# JOINT BASE SAN ANTONIO WATER MAINS – FT. SAM HOUSTON Solicitation Number: #CO-00099 SAWS Job No.: 16-7004

## ADDENDUM 2

#### November 3, 2016

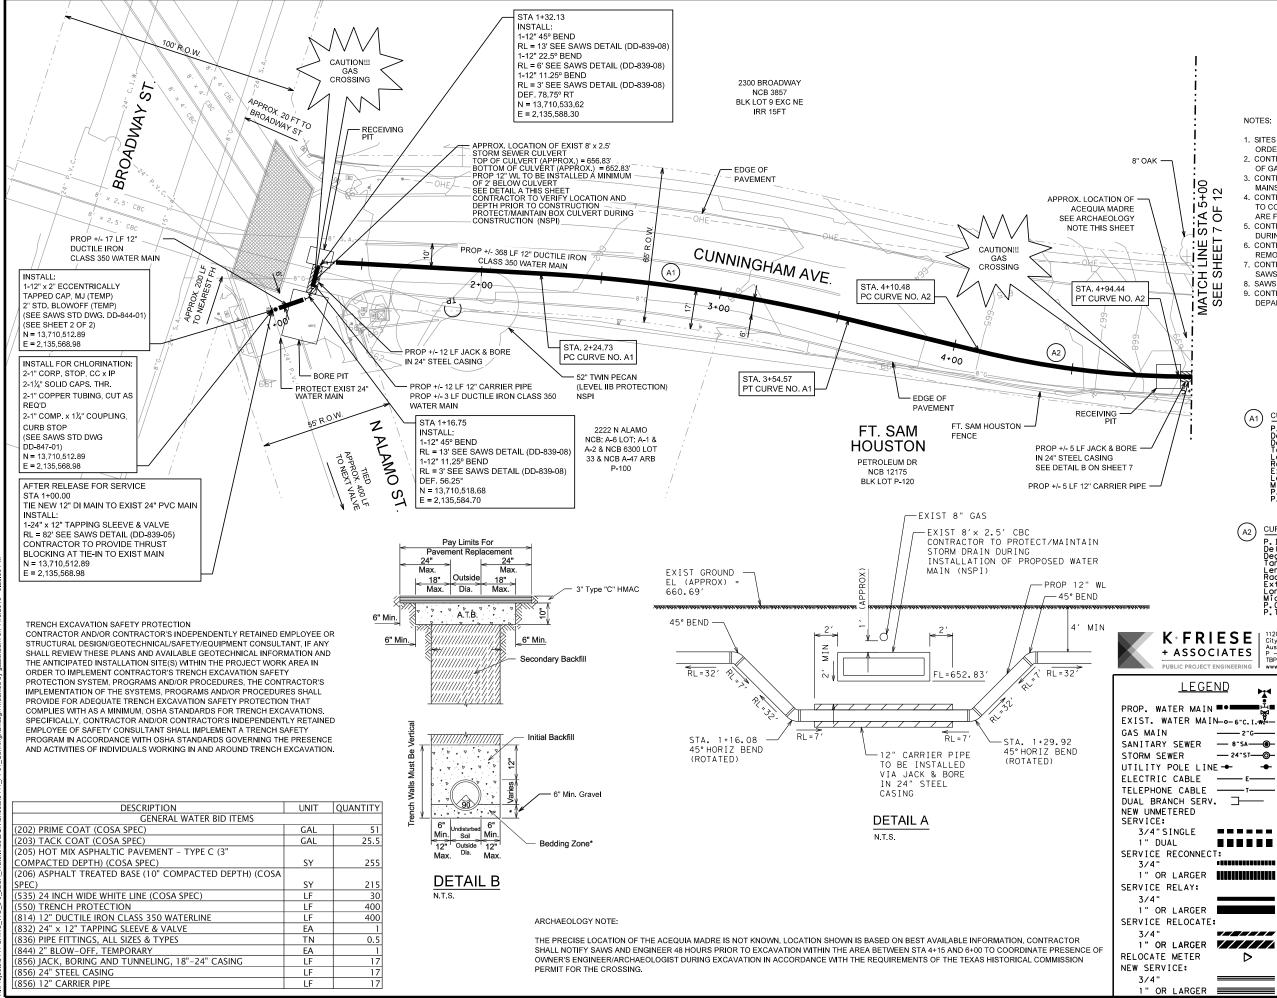
- 2. Plan Sheet 2 Revise Total Quantities table to reflect the plan changes of this Addendum. Remove and replace Sheet 2 of the plans with the attached.
